# HUMBOLDT COUNTY DEPARTMENT OF PUBLIC WORKS ROAD EVALUATION REPORT

RE: COSTA APN 516-211-025, APPS#PLN-12176-CUP

ROAD EVALUATION, REVISED; TRAFFIC MANAGEMENT PLAN

ROAD EVALUATION RESPONSE

Figure 4: Pinch point under railroad trellis with turnout in foreground. A car count was performed at this location.

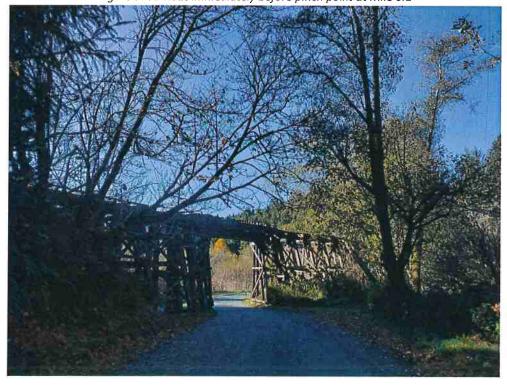
We understand that there is a pinch point at this location, but the only reasonable solution appears to be the installation of a warning sign near this location to warn oncoming traffic to pull to the side at one of the wide sections either immediately after the pinch point or before it where Warren Creek Road meets West End Road. In response to this pinch point and the possible deleterious effects it may have

- C. Signage indicating that "Road Narrows" or "One Lane Road Ahead" or similar symbolic signage should be placed at the beginning of Warren Creek Road, on both sides of the pinch point at mile 0.6, and at both ends of Section 3. A sign warning of oncoming traffic should be placed at the potentially blind corner at mile 1.5.

Picture: Recommended turnout locations

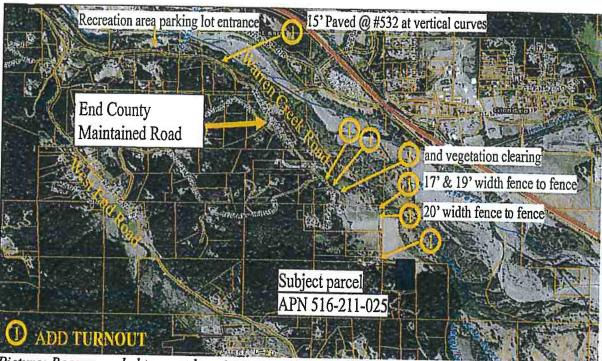
The Department evaluated the functional capacity of the road and determined that there are several areas where additional turnouts would improve the functionality of the road by increasing the indivisibility between turnouts. These turnouts are shown on the diagram below. Adding these turnouts will allow traffic to pass without the need for traffic to back up to the nearest turnout, driveway, or wide spot.

- 1. The applicant shall construct the turn-outs identified in this memo prior to commencement of operations.
- 2. That the project restricts the use of vehicles wider than a regular pickup truck to off peak hours, being 9:00 am to 4:00 pm weekdays.
